**MONTGOMERY COUNTY PLANNING DEPARTMENT**  
 THE MARYLAND-NATIONAL CAPITAL PARK AND PLANNING COMMISSION

**Staff Report: Limited Site Plan Amendment 82001009C, Milestone Business Park**

**REPORT DATE:** February 7, 2011

*Rendered Cross Section*

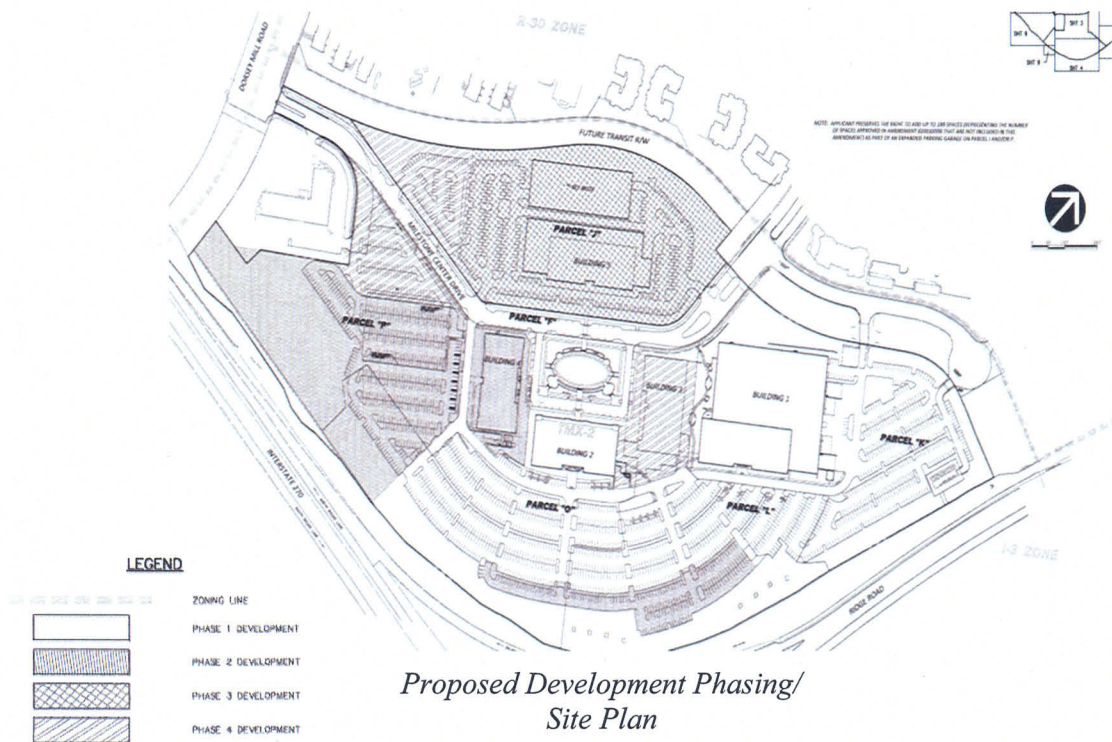
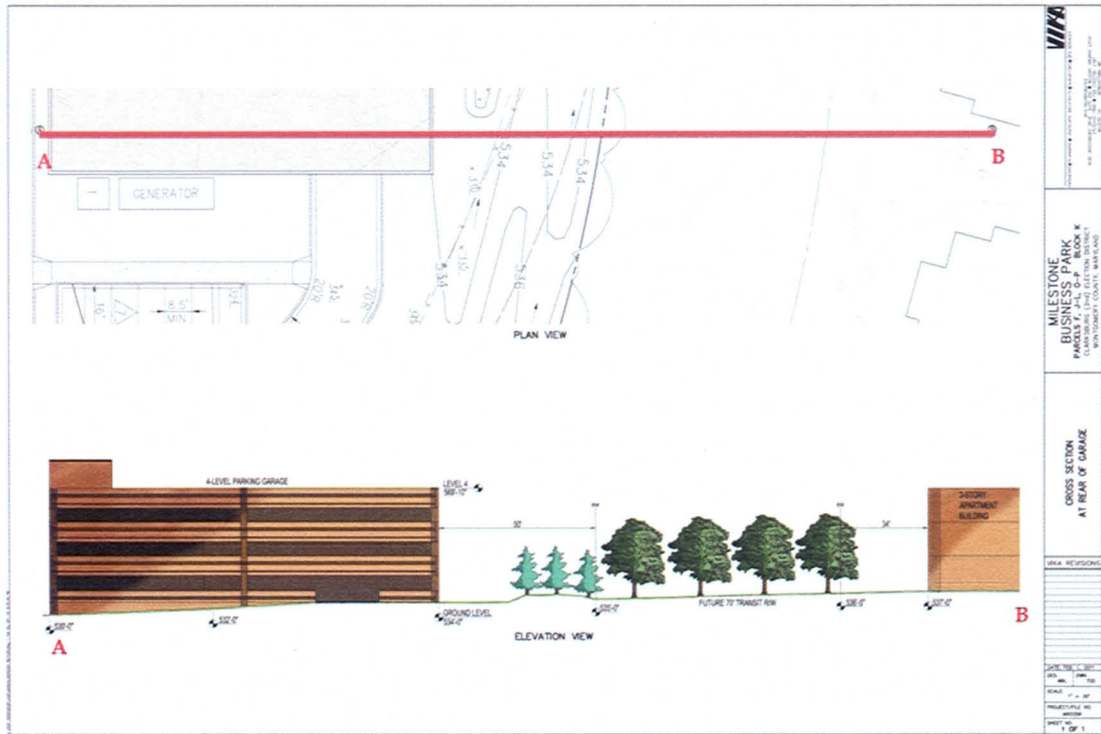
III. The construction of Phase III, Building 5 and associated parking facilities. The total density to be transferred to phase IV is 25,550 square feet; which will include the square footage permitted for the retail and restaurant uses. The construction of Building 5 will consist of office and light industrial uses only. The structural modifications to Building 5 include a reduction to the height by 1-story and to the area by 5,000 square feet. The structural modifications proposed for the parking garage included a reduction to the width of the building footprint by 76,013 square feet and an increase to the total height by 2-levels.

**SITE, GRADING AND UTILITY PLAN**

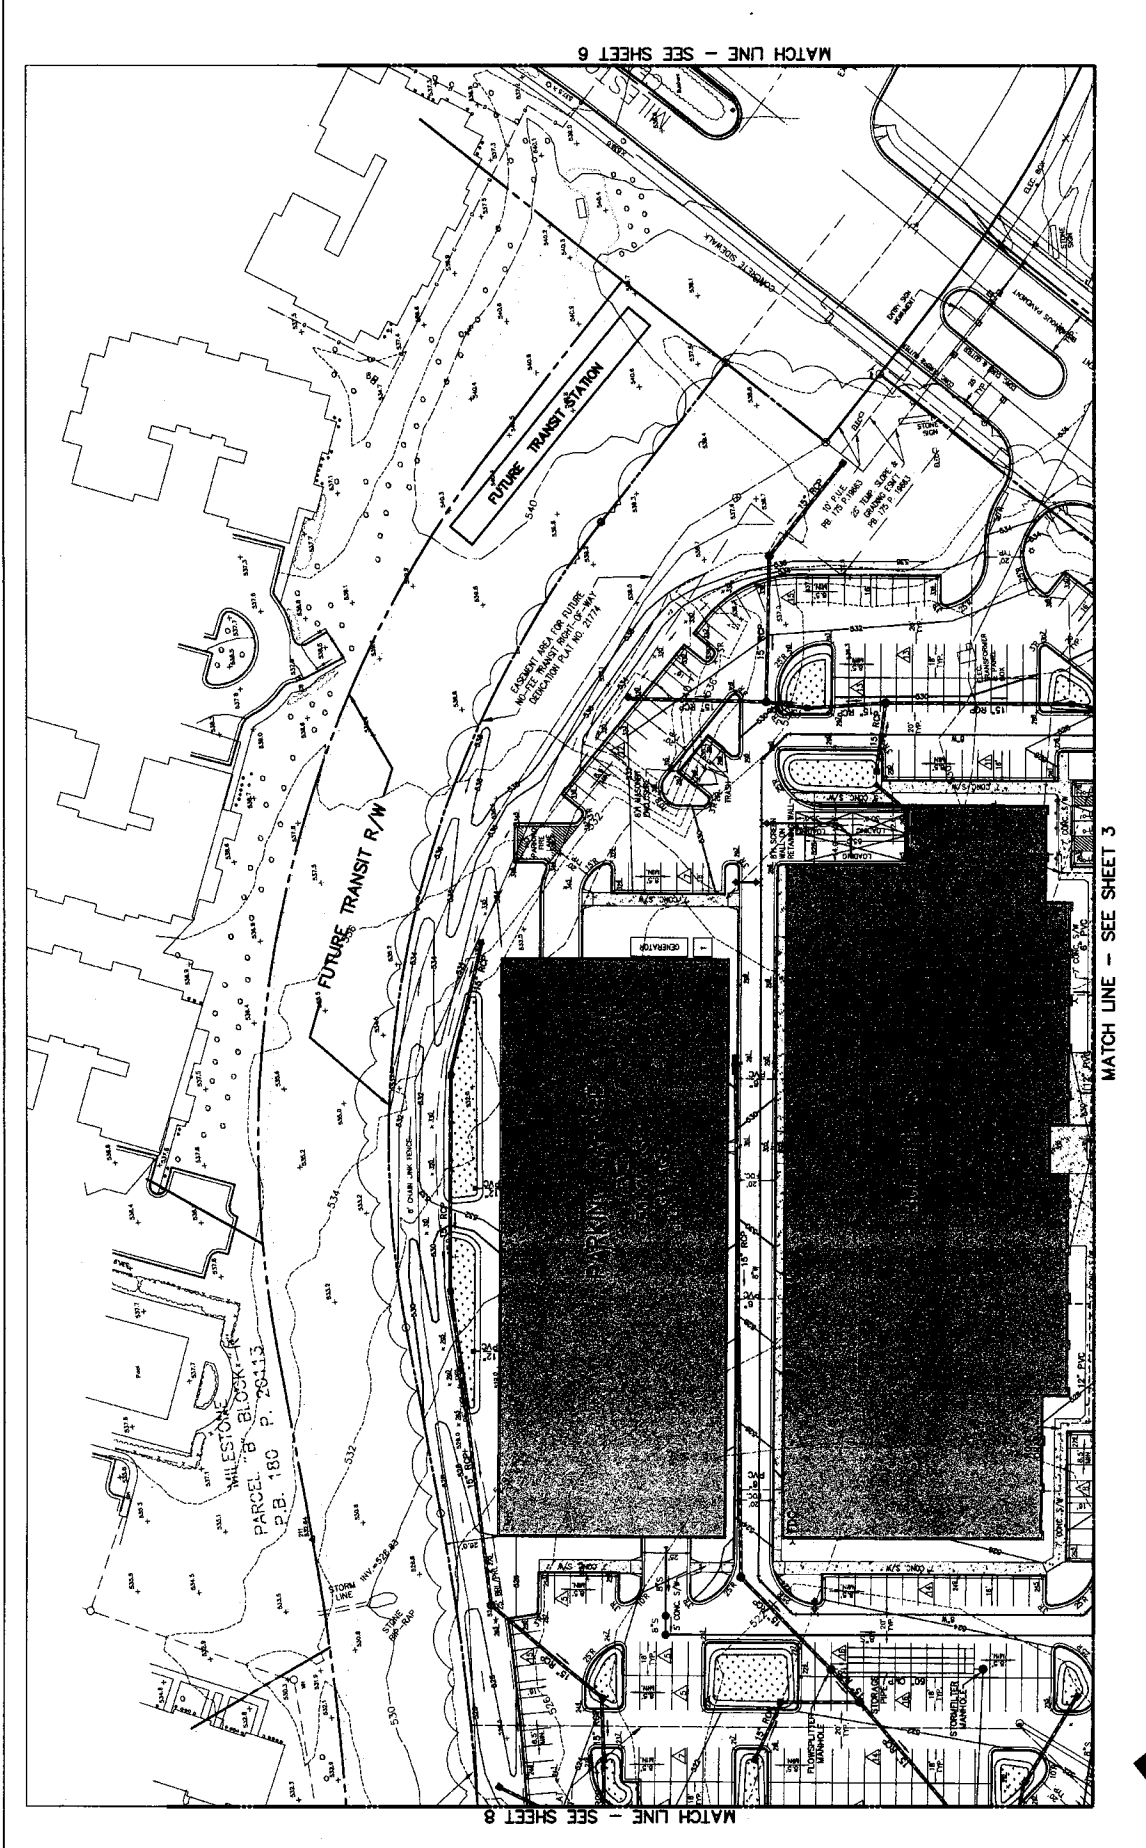
**SITE PLAN AMENDMENT - BUILDINGS**  
 THE SITE PLAN IS REVISED PER THE AMENDMENT TO REFLECT THE FOLLOWING:  
 1) MODIFY BUILDING FOOTPRINTS AND USES FOR THE BUILDINGS SHOWN.  
 2) MODIFY UTILITY LINES AND LOCATIONS FOR THE BUILDINGS SHOWN.  
 3) MODIFY SITE PLAN TO REFLECT THE ABOVE CHANGES.  
 4) VERIFY THE ACCURACY OF THE SITE PLAN TO REFLECT THE ABOVE CHANGES.  
 5) VERIFY THE ACCURACY OF THE SITE PLAN TO REFLECT THE ABOVE CHANGES.

**FUTURE PARKING DECK PLAN**  
 BUILDING #4

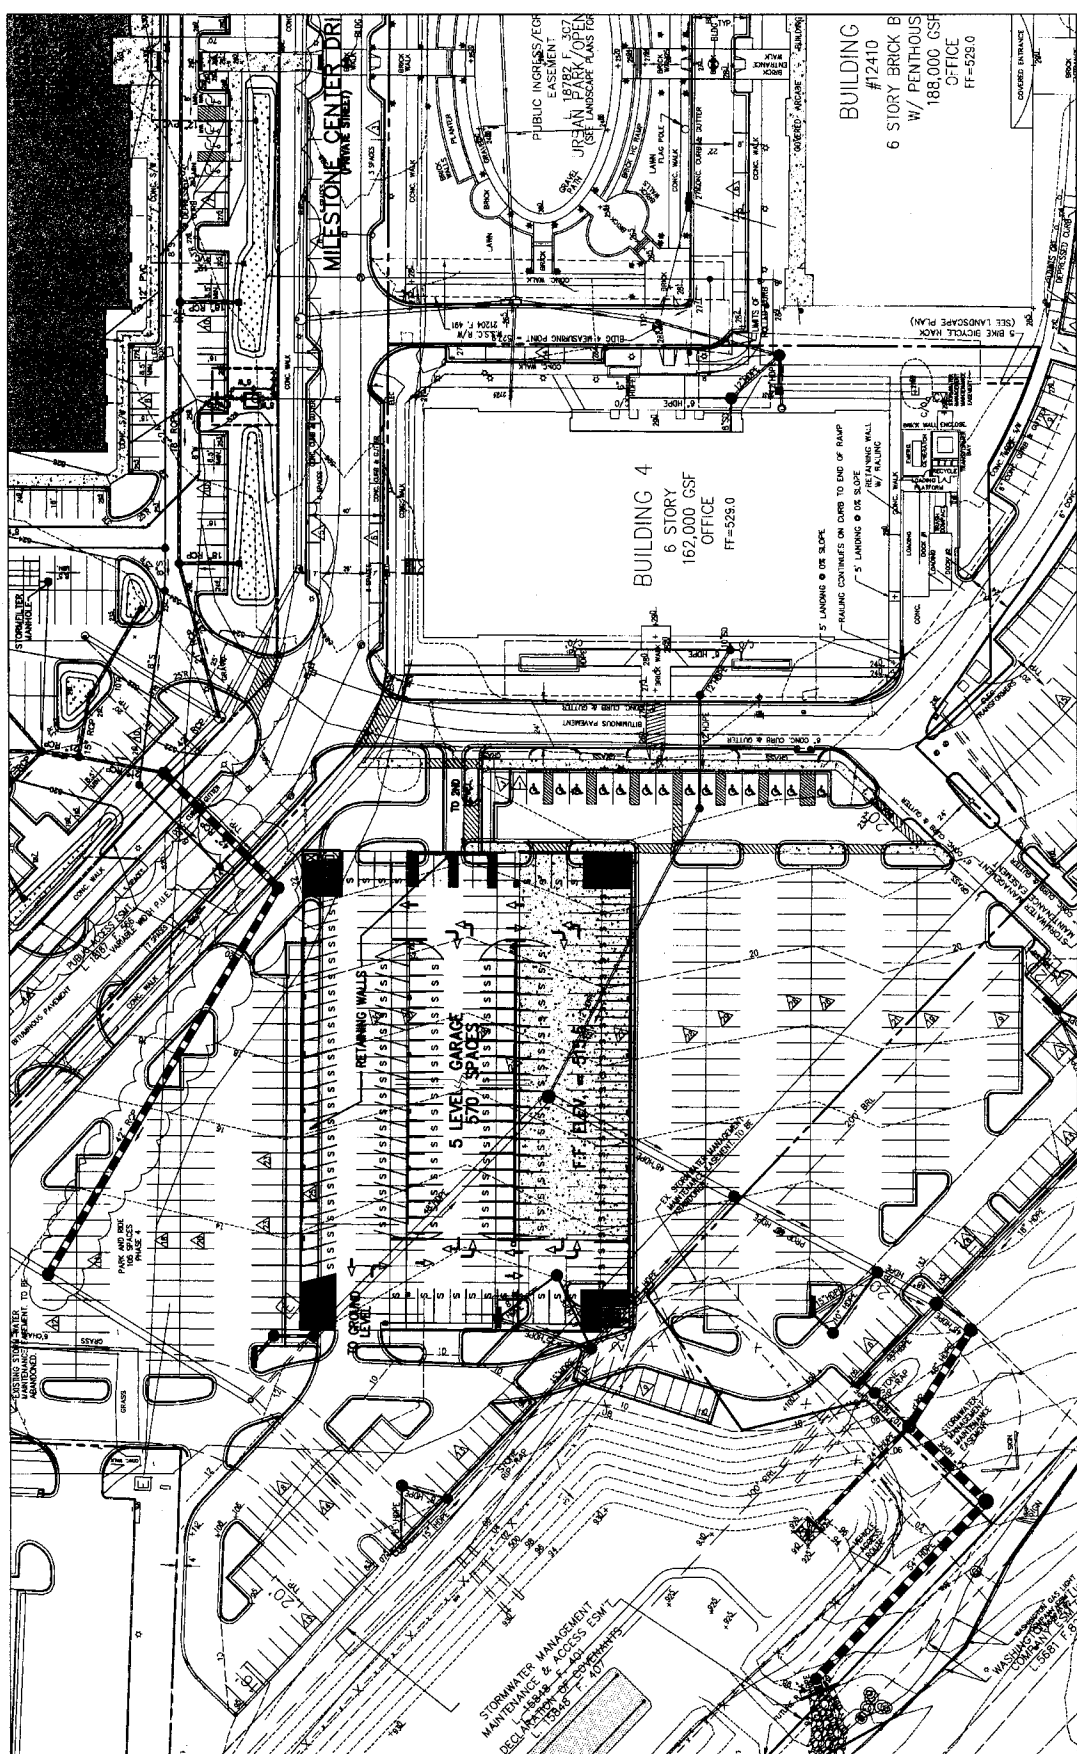
**SITE PLAN AMENDMENT - 2010/08/13**  
 THIS SITE PLAN IS REVISED FOR THE AMENDMENT TO REFLECT THE FOLLOWING:  
 1) ADDED BUILDING, PARKING AND LINES FOR THE PROPOSED PARKING DECK AND RETAINING WALLS.  
 2) ADDED RETAINING WALLS AND ELEVATION.  
 3) ADDED RETAINING WALLS AND ELEVATION.  
 4) ADDED RETAINING WALLS AND ELEVATION.  
 5) ADDED RETAINING WALLS AND ELEVATION.  
 6) ADDED RETAINING WALLS AND ELEVATION.  
 7) ADDED RETAINING WALLS AND ELEVATION.  
 8) ADDED RETAINING WALLS AND ELEVATION.  
 9) ADDED RETAINING WALLS AND ELEVATION.  
 10) ADDED RETAINING WALLS AND ELEVATION.

**LANDSCAPE AND LIGHTING  
 PLAN OVERVIEW**

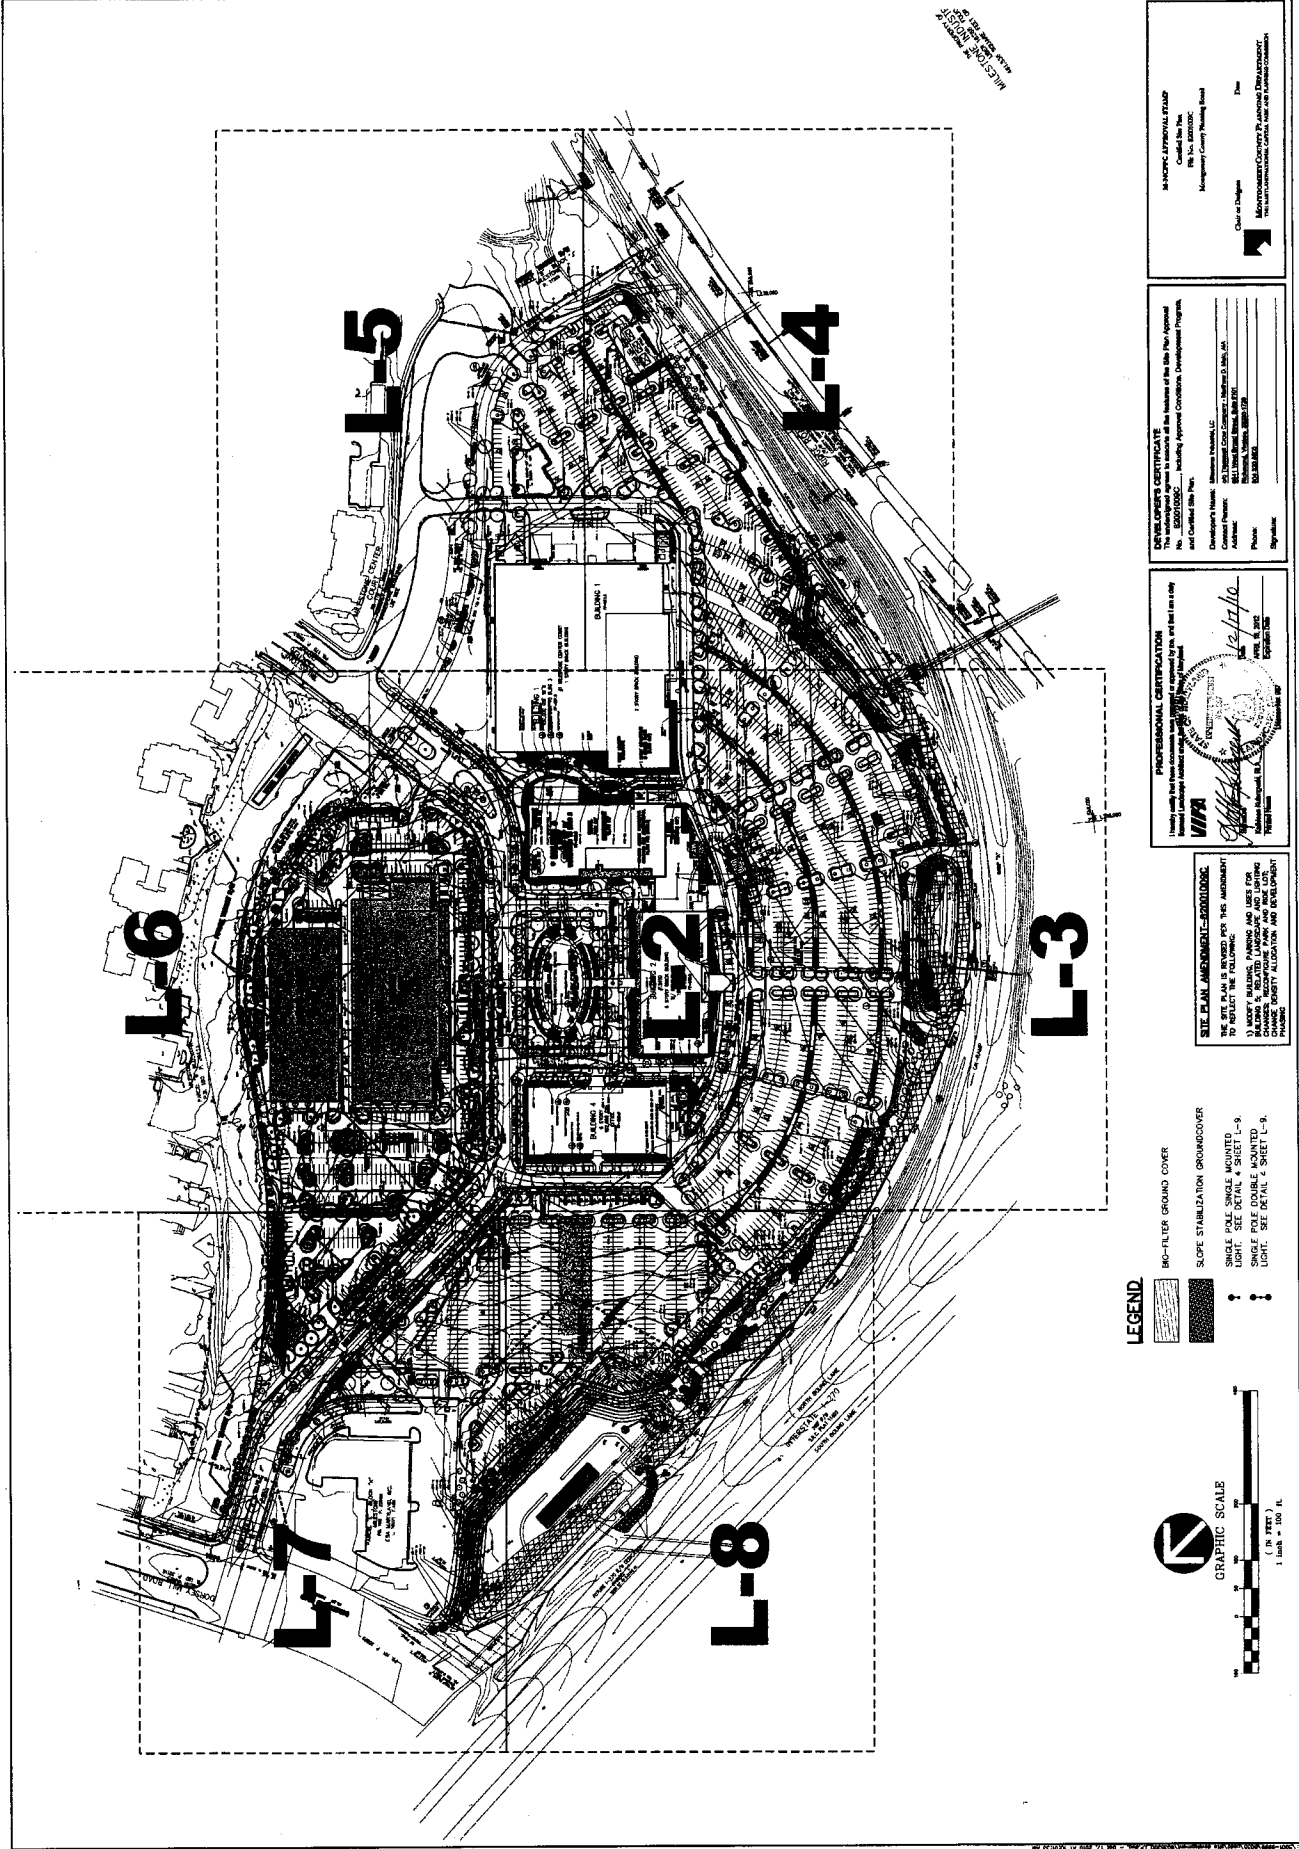
**SITE PLAN AMENDMENT - BUILDING**  
 THE SITE PLAN IS REVISED FOR THIS AMENDMENT TO REFLECT THE FOLLOWING:  
 1. ADDITION OF BUILDING FOOTPRINTS  
 2. ADDITION OF RELATED LANDSCAPE AND LIGHTING  
 3. CORRECTED PROPERTY ADDRESS AND AGENCY PROJECT NUMBER

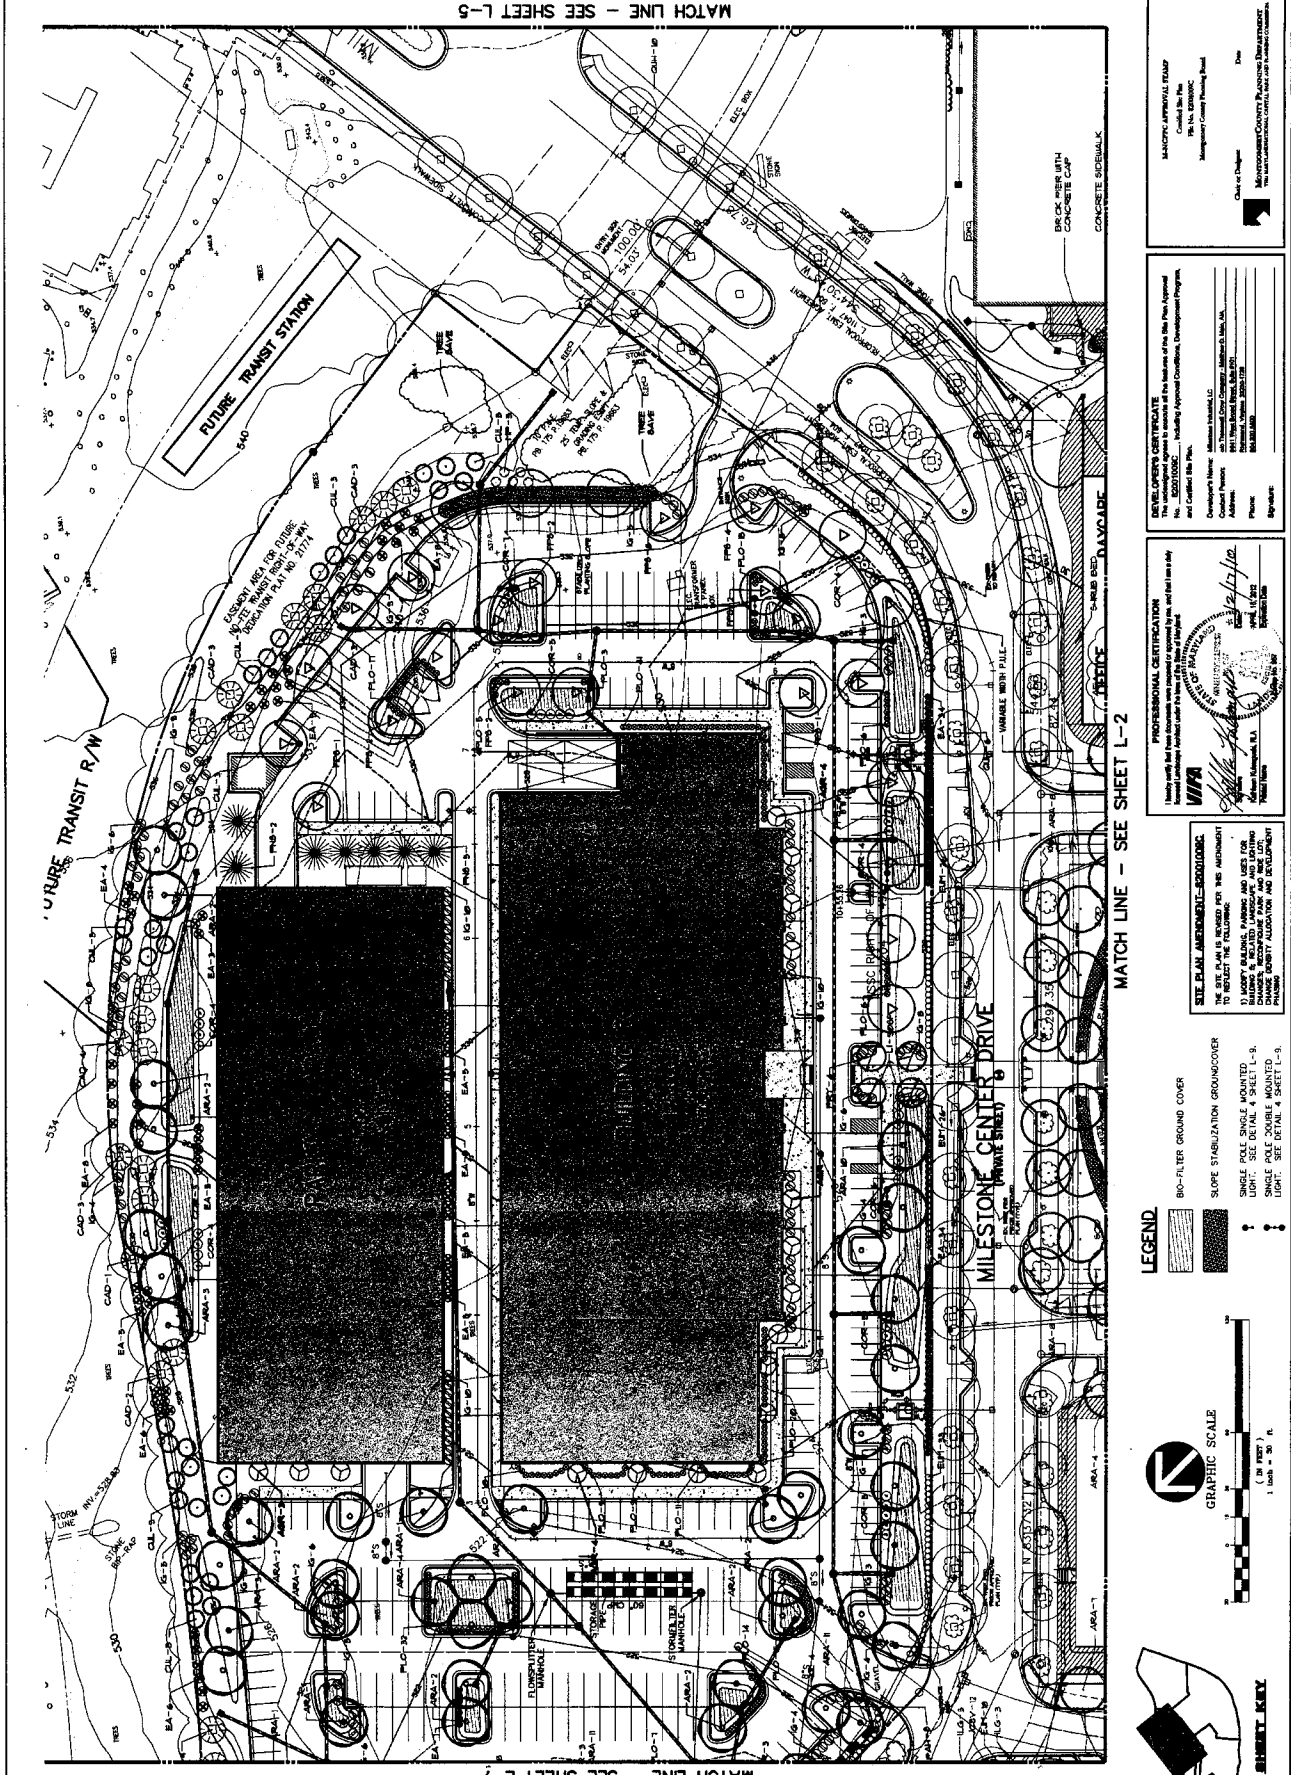
**NOTE: PLAN AMENDMENT - ADDITIONAL**  
 THE SITE PLAN IS REVISED FOR THIS AMENDMENT  
 TO REFLECT THE FOLLOWING:  
 1) ADDED PLANTING, FURNITURE AND LIGHTS FOR  
 CHANGES, RECONSTRUCTION AND NEW LOT  
 PLANNING. SEE SHEET L-2 FOR ADDITIONAL  
 PLANNING.
